From: Andrew Galuska <agaluska@mukilteowa.gov>
Sent: Friday, February 3, 2023 10:00 AM
To: David Tyler
Cc: Sarah Kress
Subject: RE: Harbor Grove

Based on this analysis I have concluded that the retaining walls proposed in the Harbor Grove plat are approvable. Ultimately, the plat approval will be issued by the Hearing Examiner, but this is the finding of staff.

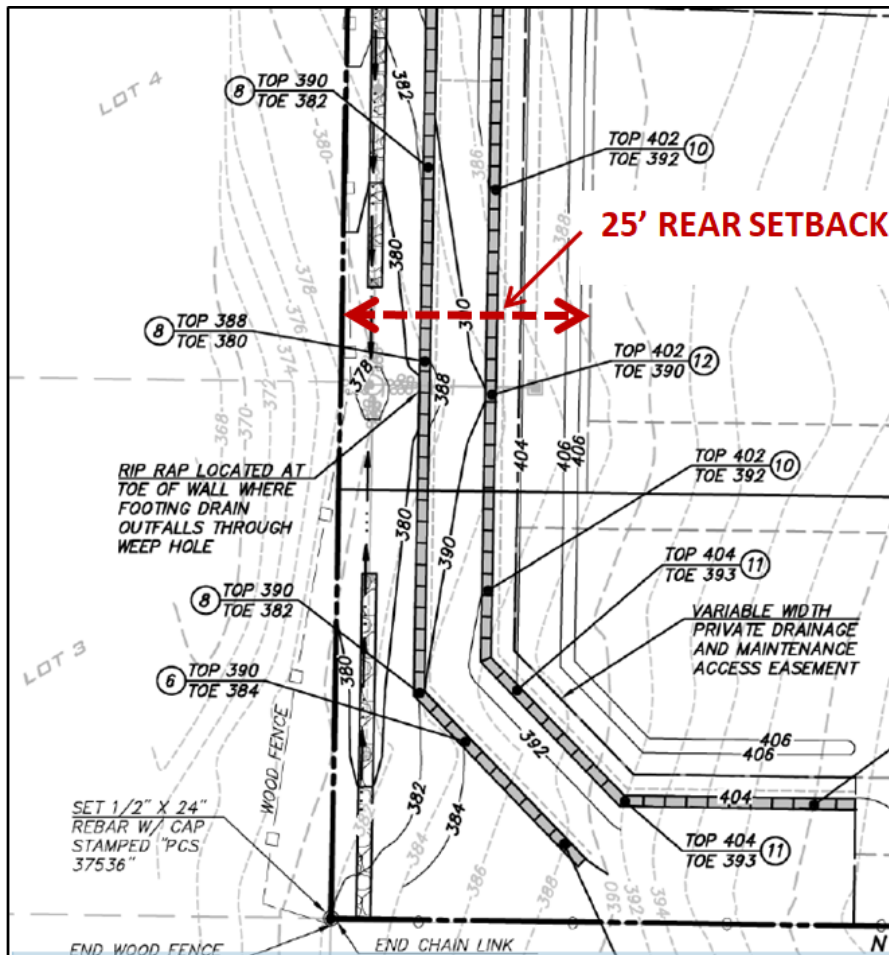
MMC 17.20.080 refers to freestanding walls, which we do regulate like fences. However, the applicant is proposing retaining walls which are not regulated in the same manner. The project proponent is proposing landscaping to help reduce the visual impacts on the neighboring properties.

Thanks for the follow-up on this issue. Here's the code section I found and cited in a previous comment letter to Linda Ritter. Seems like it limits wall height to six feet in the rear setback. This is not an unusual requirement--Everett had something similar. For the project, the combined wall height within the rear setback is 20 feet on Lots 6 and 7. Linda never addressed this in her letter of Feb. 17, 2022. This is a critical issue for the neighbors in Rugosa that will most assuredly be raised during the SEPA process if it is not addressed prior to. I have developed some graphic information I would like to share with you at some point showing the impacts of these walls and grade changes on the site.

The code specifically names free standing walls in MMC 17.20.080, so it seems that the council's intent in that section did not include retaining walls. I would say in general setback regulations do not commonly regulate retaining walls. It is often necessary to locate retaining walls for certain improvements.

MMC 17.20.080 does discuss height of fences in setbacks. The code section specifically specifies how fence height is calculated when they are located on top of retaining walls, which implies retaining walls are permitted in the setback. To confirm this interpretation, I went back through several previously approved plats and was able to find several instances of retaining walls permitted in front, rear, and side setbacks.
